To: The Design Advisory Board
From: Mary O'Neil, AICP, Principal Planner
RE: ZP18-0481SP; 298 College Street
Date: Wednesday, December 13, 2017

File: ZP18-0481SP
Location: 298 College Street (former Ethan Allen Club)
Zone: RH **Ward:** 8E
Parking District: Neighborhood
Date application accepted: November 13, 2017
Additional material submitted: November 30 and December 1, 2017
Applicant/ Owner: Freeman French Freeman, Inc. / Kyle Dodson for Greater Burlington YMCA
Original Technical Review: February 11, 2016
Next Technical Review: December 14, 2017
Request: Redevelopment of the former Ethan Allen Club for the Greater Burlington YMCA; Basement plus two stories, approximately 65,000 sf (22,000 sf footprint.) Request for parking waiver.
Background:

Overview: This is Sketch Plan Review for the proposed redevelopment of the former Ethan Allen (membership) Club to the Greater Burlington YMCA. The existing building is proposed to be demolished, a replacement structure of approximately 65,000 sf with 39 parking spaces on-site, 12 off-site planned. A 73% parking waiver is requested.

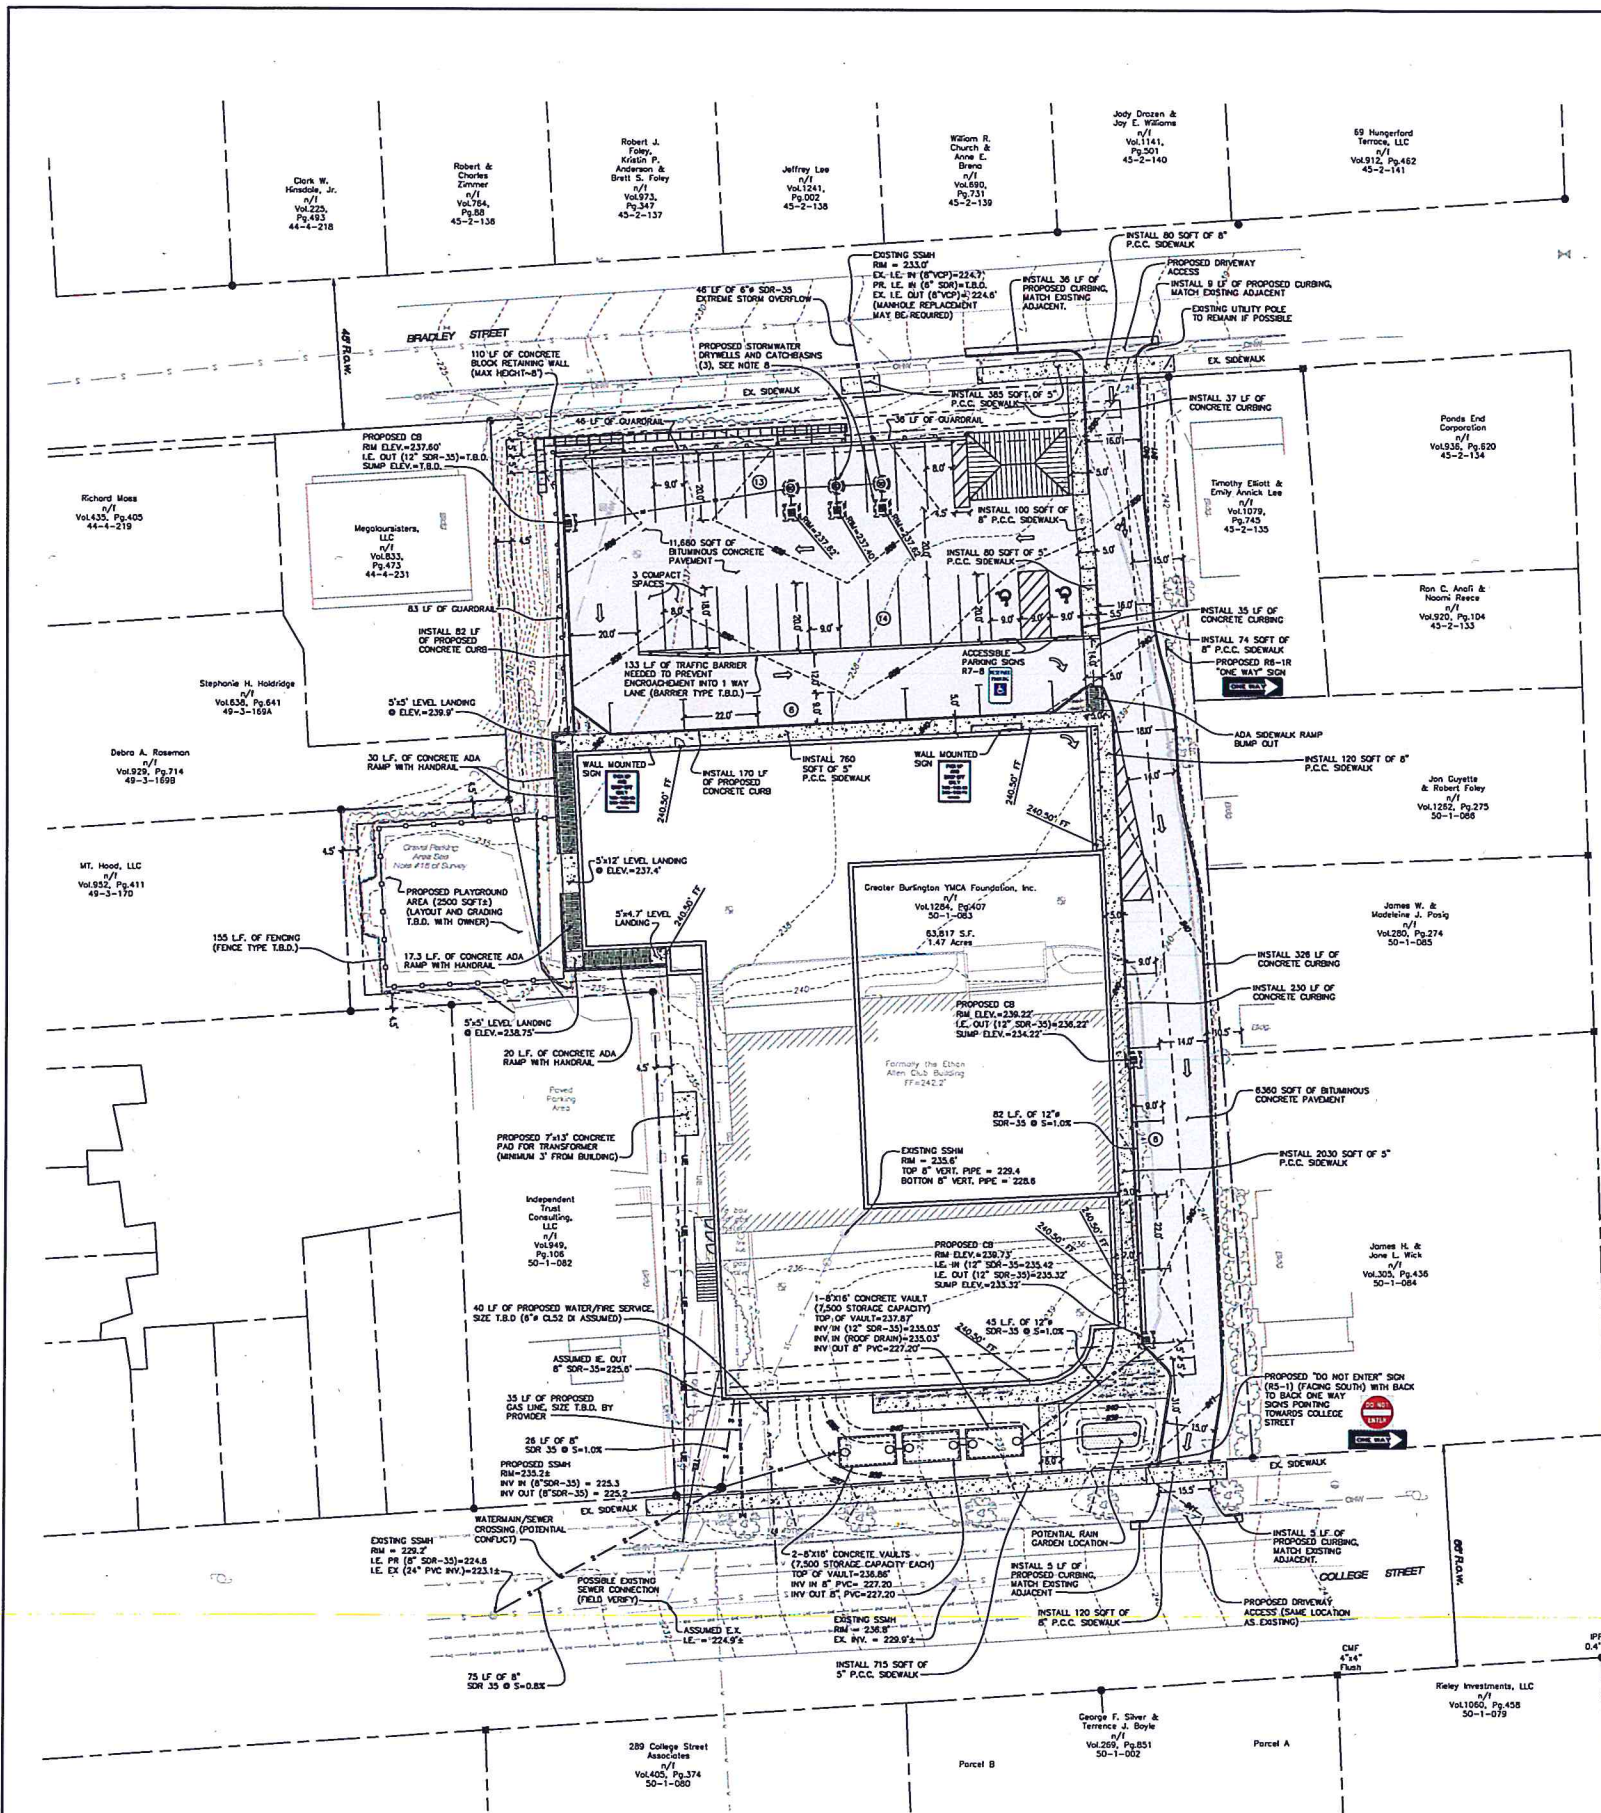
The new structure has chosen its primary face fronting College Street; the Bradley Street façade recessed from the street and behind a parking lot and smaller structures. (illustrated on the site plan, more info provided on "Bike Shelter Floor Plan.") Both are minor accessory structures, intended for storage and bikes. The designs are deferential yet consistent in design with the principal structure. Their placement, however, remains in a highly visible location on Bradley Street, a predominantly residential neighborhood. The essential problem is how the redevelopment addresses Bradley Street, where a prominent building presence is desired, rather than a parking lot with screening.

Section 5.1.2, (e), *Accessory Nonresidential Structures*, limits accessory structures to 500 square feet. The structures illustrated contribute a total of 840 sf. (588 and + 252 sf); in excess of the 500 sf limitation.

Unfortunately, the north street building frontage does not demonstrate alignment with neighboring buildings to reinforce the street edge but tends to duplicate the existing expanse of parking, albeit with two accessory structures and a fence-atop-retaining wall. The proposal plans to extend the siding (which matches the main building beyond) as a skirt down to grade below the interior finish floor.

The retaining wall with wooden guardrail proposed for the north street front of the lot has a preliminary estimate of 99' linear feet along Bradley Street with a height up to 8'. With no principle structure to fill in the street wall, the plan threatens to deaden the pedestrian experience with parking and sheds along the streetfront. The accessory uses (parking, storage) have secured a position in a place of prominence and visibility, treating it as a back yard rather than a street frontage. Plainly, the plan turns its back on Bradley Street, contrary to this standard.

Accessory structures should be placed in a less visible location; deferential to the principal structure or use. Alternately, the plan may move toward a Planned Unit Development where more than one principal building occupy the site (RH has no minimum project size). A second building, fronting Bradley Street would satisfy strengthening both street walls with new development, which may include these accessory uses.

39 parking spaces are proposed on-site, with another 12 off site (Location? Lease agreement?) For the proposed use, 188 parking spaces are required by the Comprehensive Development Ordinance. A 73% parking waiver will be requested. See attached Memorandum. Vehicular circulation is proposed from the north, in a counter clockwise circulation pattern through the parking area, existing to the main drive and onto College Street. A drop-off location is identified adjacent to rear entrances, with signage limiting parking during drop off times. That

The two accessory structures on the north of the site remain in a highly visible (rather than deferential) location.

Trash bins are identified within one of the accessory structures fronting Bradley Street, meeting the requirement *enclosed on all four (4) sides to prevent blowing trash, and screened from public view*. The buildings, themselves, are in a highly visible location along a public street.

SOUTH ELEVATION

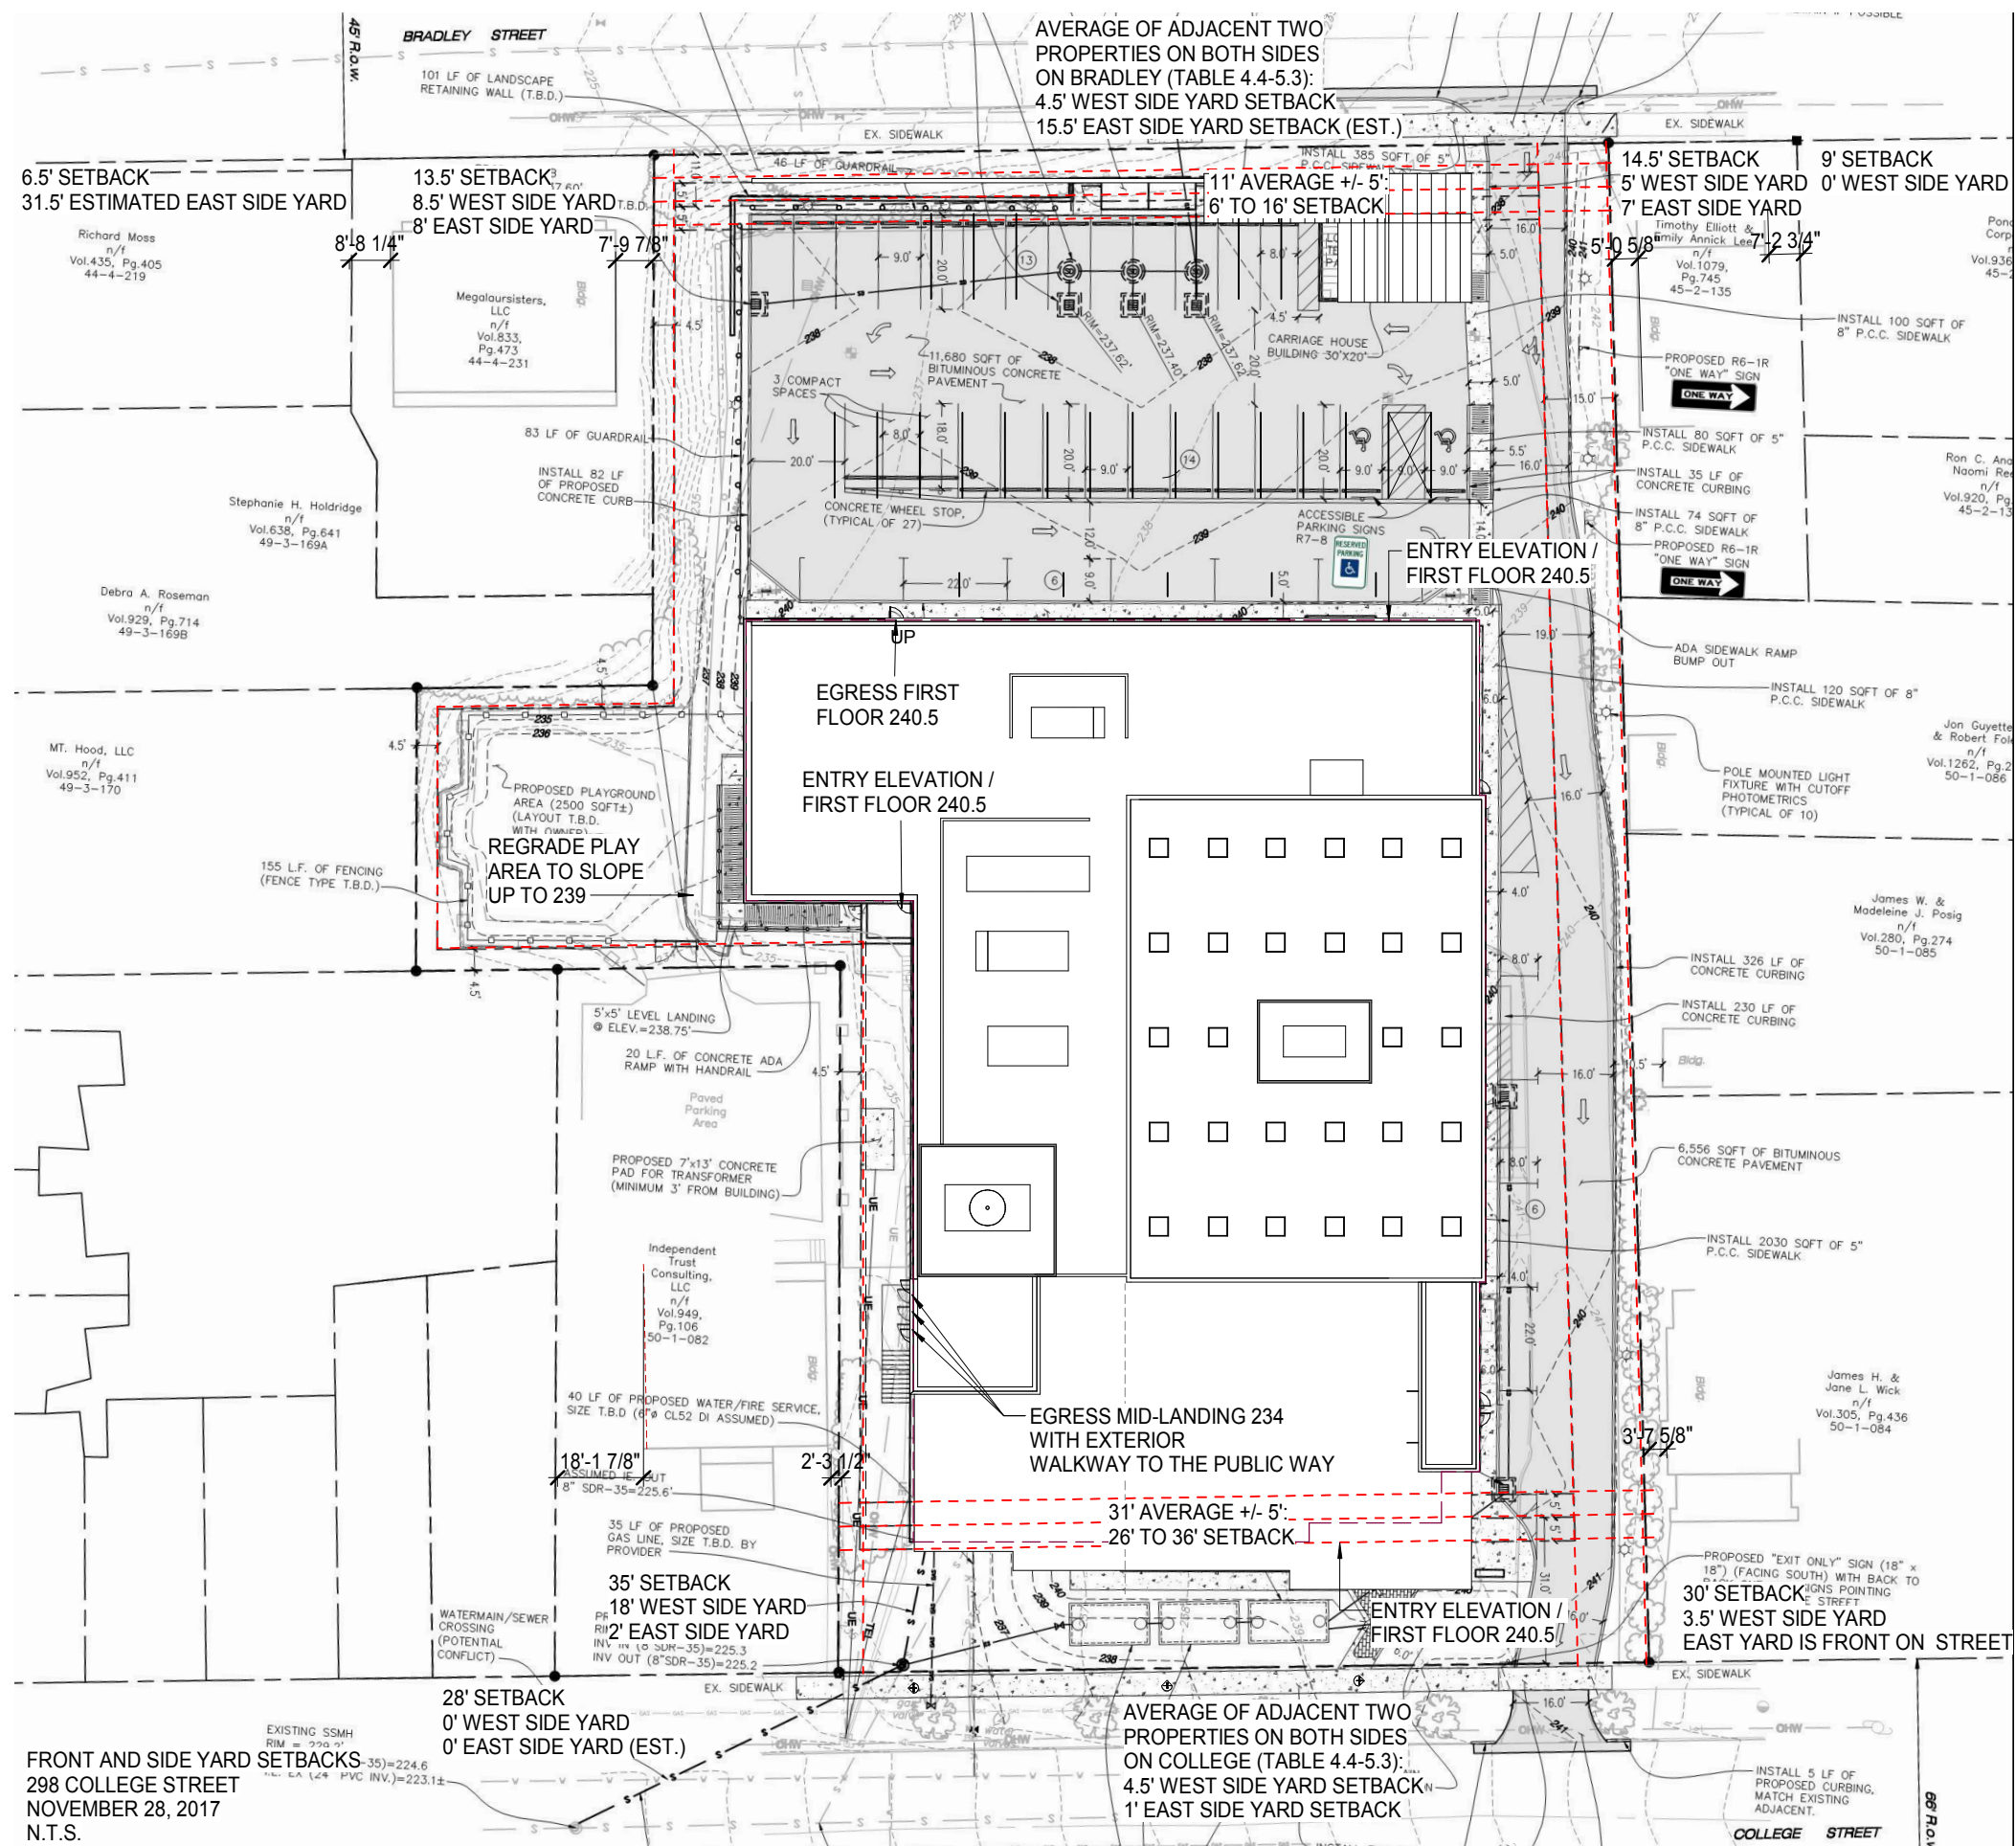
Elevations define building segments, each with its own rhythm and window arrangement. The 2nd floor of the College Street (primary) façade is largely glazed, with a full two story glassed entrance wall. The first floor has paired sets of windows. The north elevation has an assortment of paired single windows, as well as ribbons of grouped sash. Spandrel panels or colorful casings accentuate the openings.

The north elevation features bubble-like features on the lower floor, and 5 pairs of larger windows on the 2nd floor. The fenestration on the west elevation is playful as well; windows are set in the same horizontal plane, but spandrels, casings, and building divisions provide interest and movement.

Any signage will require a separate sign permit. The innovative arrangement of the cedar shakes to create the “Y” emblem (east and north elevations) constitutes a sign.

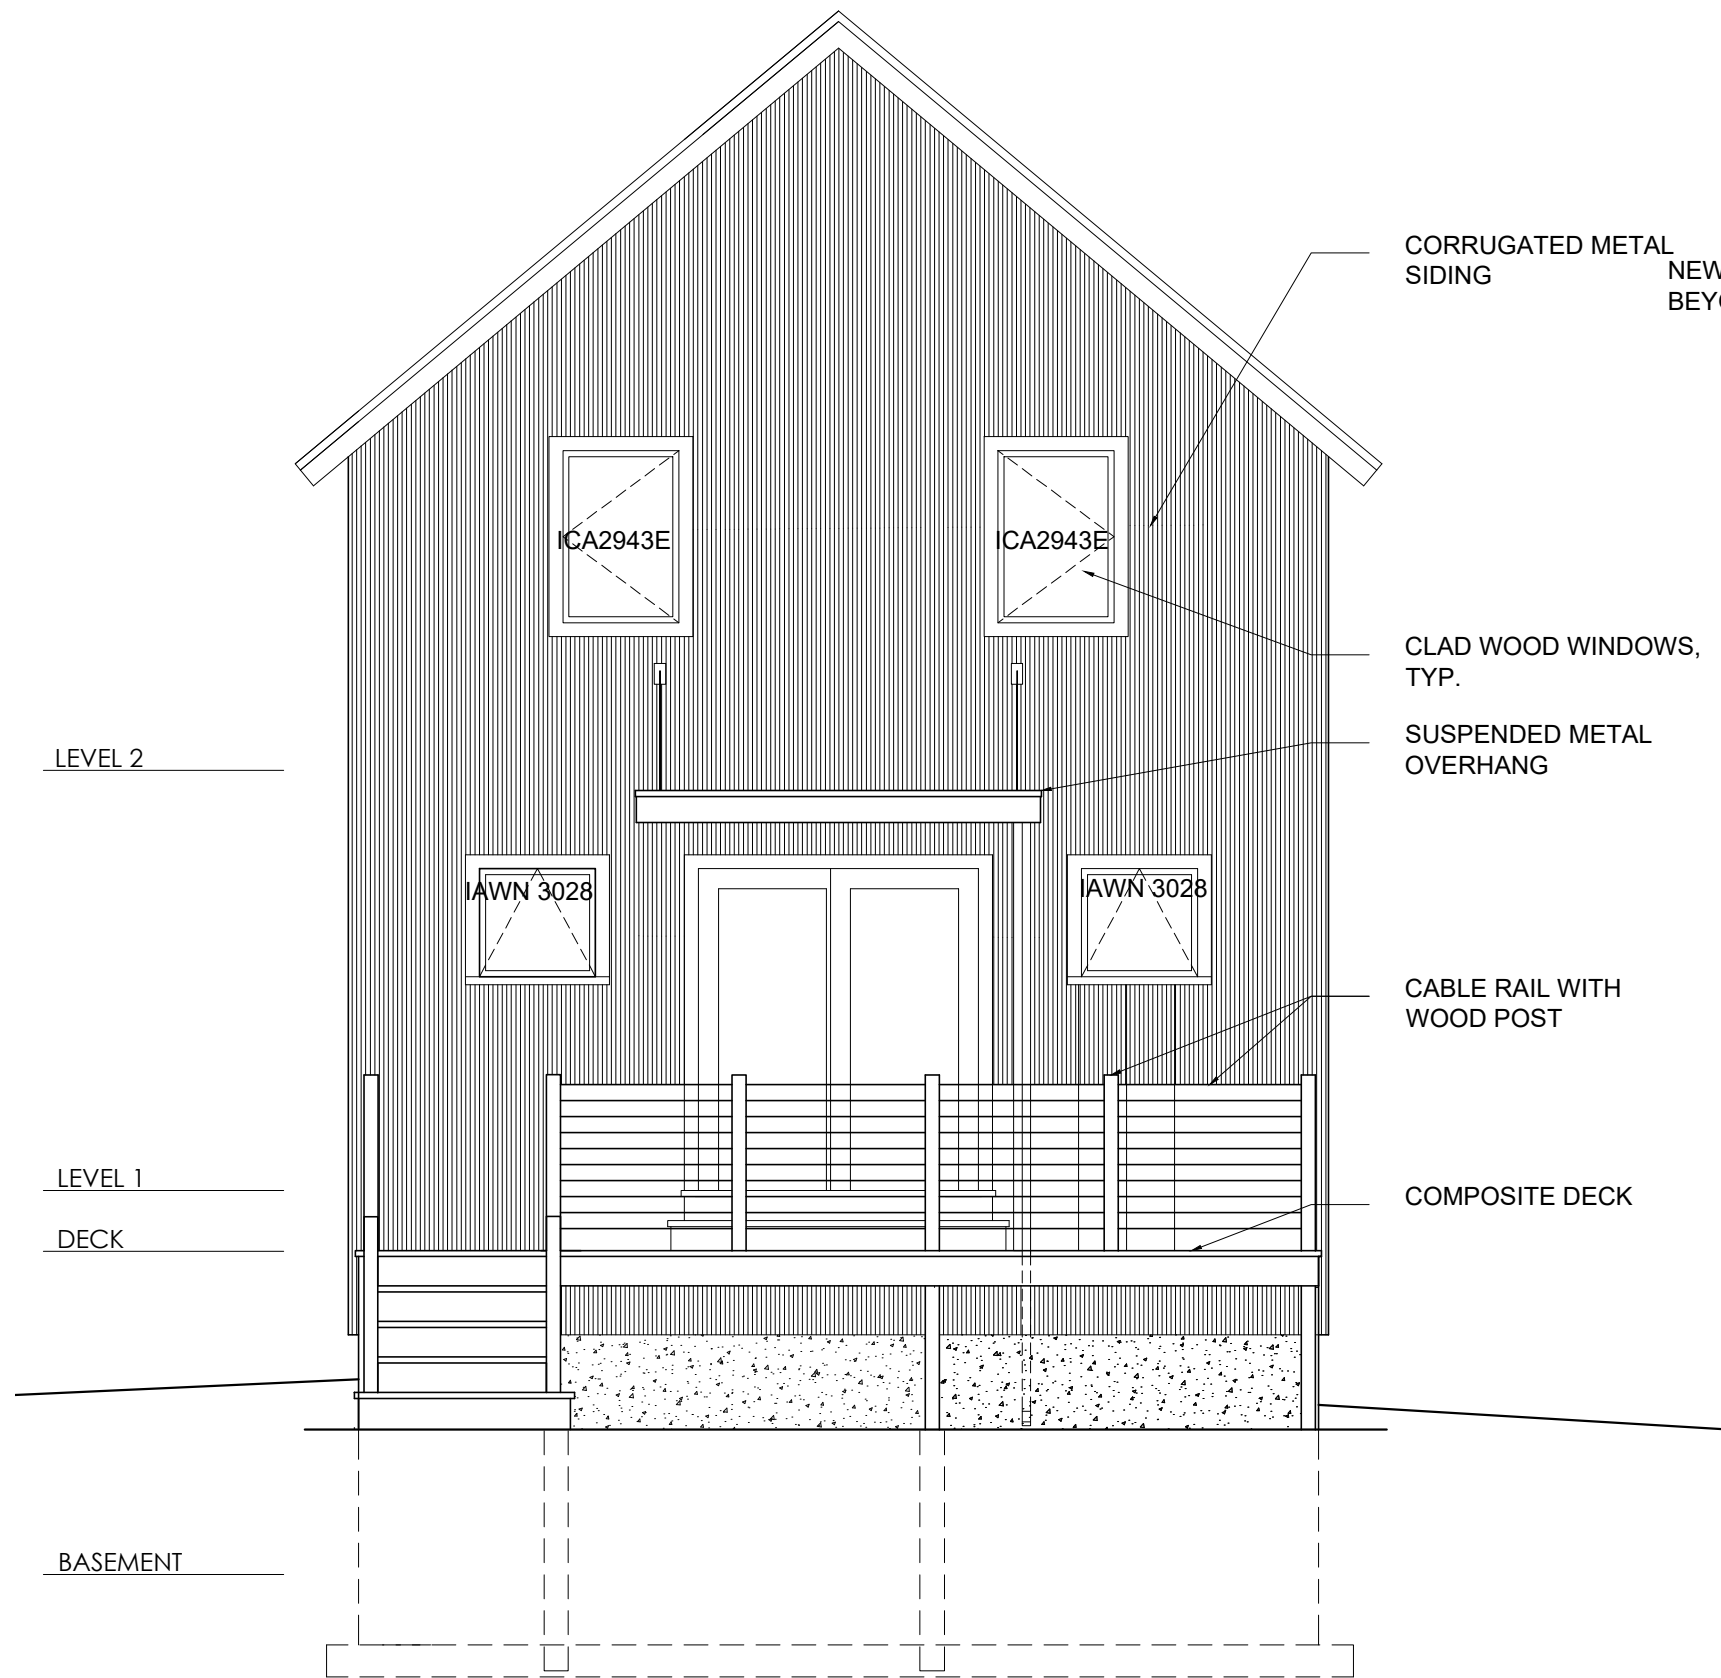
The new addition is clearly differentiated from the existing home. The materials and form of the new addition are acceptable. The increase in height and mass; however, threatens to invert the primary versus subordinate relationship between the existing historic home and the

addition. While the scale of the addition does not consume the original structure, its larger mass and increased height do, in fact, make it more visible from the street and lessen focus on the original structure. As proposed, the addition would break from the established neighborhood pattern, further eroding its historic integrity.
